TECHNICAL REVIEW COMMENTS
April 2012 Kalamazoo River Hydrodynamic and Sediment Transport Model
Report
Enbridge Line 6B MP 608 Marshall, MI Pipeline Release

BY USGS AND WESTON/START ON BEHALF OF U.S. EPA
August 22, 2012

Figure 5-6 Floodplain model validation
Sediment Mass Flux

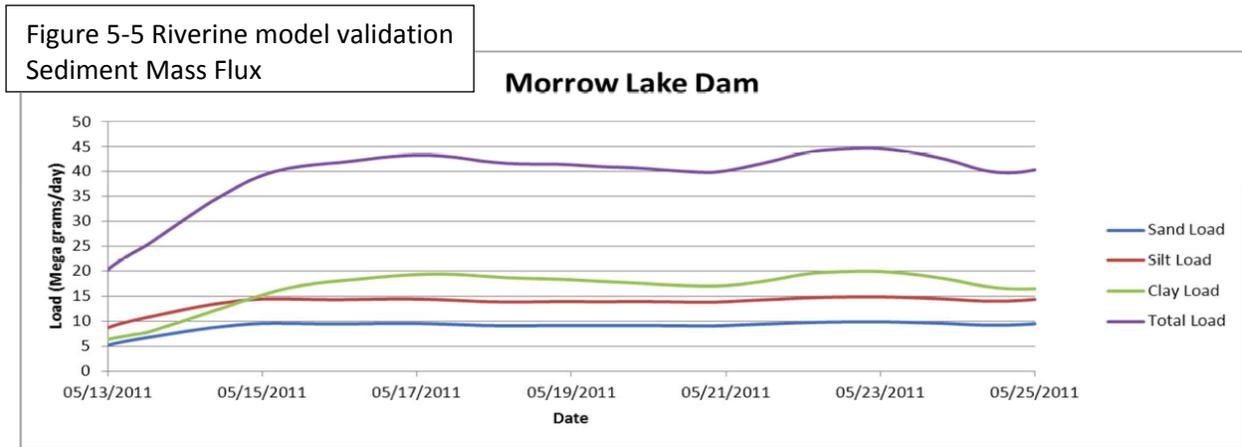
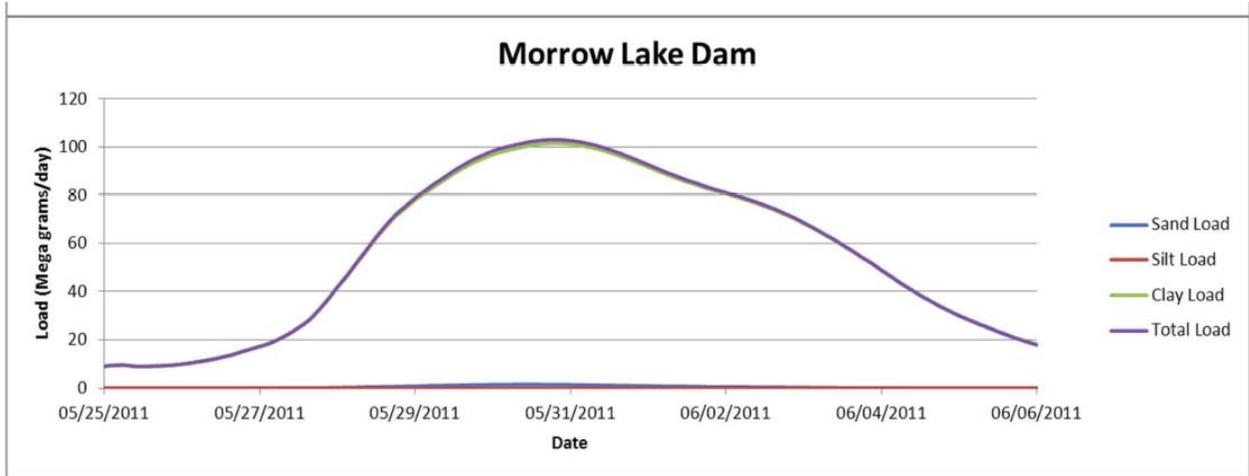
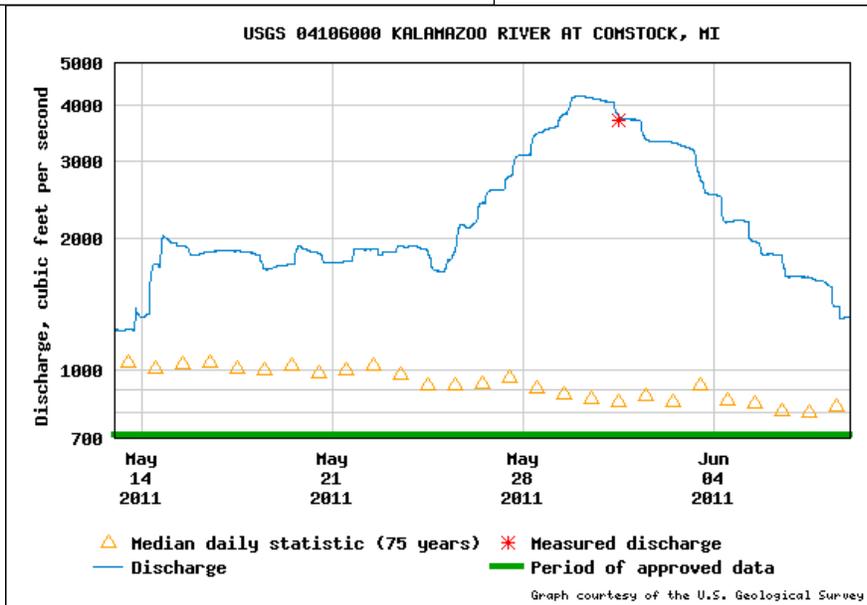
For sediment mass flux, mass flux was highest on the first day of the riverine model for upstream locations, when flows were the lowest. This is likely an artifact of equilibration at the startup of the model as it did not carry through to Morrow Lake Dam (see below). Keeping in mind the limited interpretations that can be made from an uncalibrated, unvalidated sediment transport model, it is noteworthy that the riverine model shows sand, silt, and clay, totaling about 40 Mg/d, passing Morrow Lake Dam from May 15 to May 25, 2011 yet for the floodplain model virtually only 10 Mg/d of clay passes Morrow Lake Dam on May 25, 2011, rising to 100 Mg/d of clay on May 31, and falling to 20 Mg/d of clay on June 8. A comparison of the riverine and floodplain graphs below clearly illustrates why the sediment transport outputs from the April 2012 model need to be used with extreme caution and further justify the need for an updated model following the iterative process outlined in the CWP. These results presented below are especially critical in meeting objectives 1 and 2 of the model – successfully calibrating a model capable of simulating entrainment, transport, and deposition of sediment-oil mixtures and understanding the transport of submerged oil for different flow regimes--- in terms of providing supporting information for meeting the U.S. EPA order of “no oil past Morrow Lake Dam”.
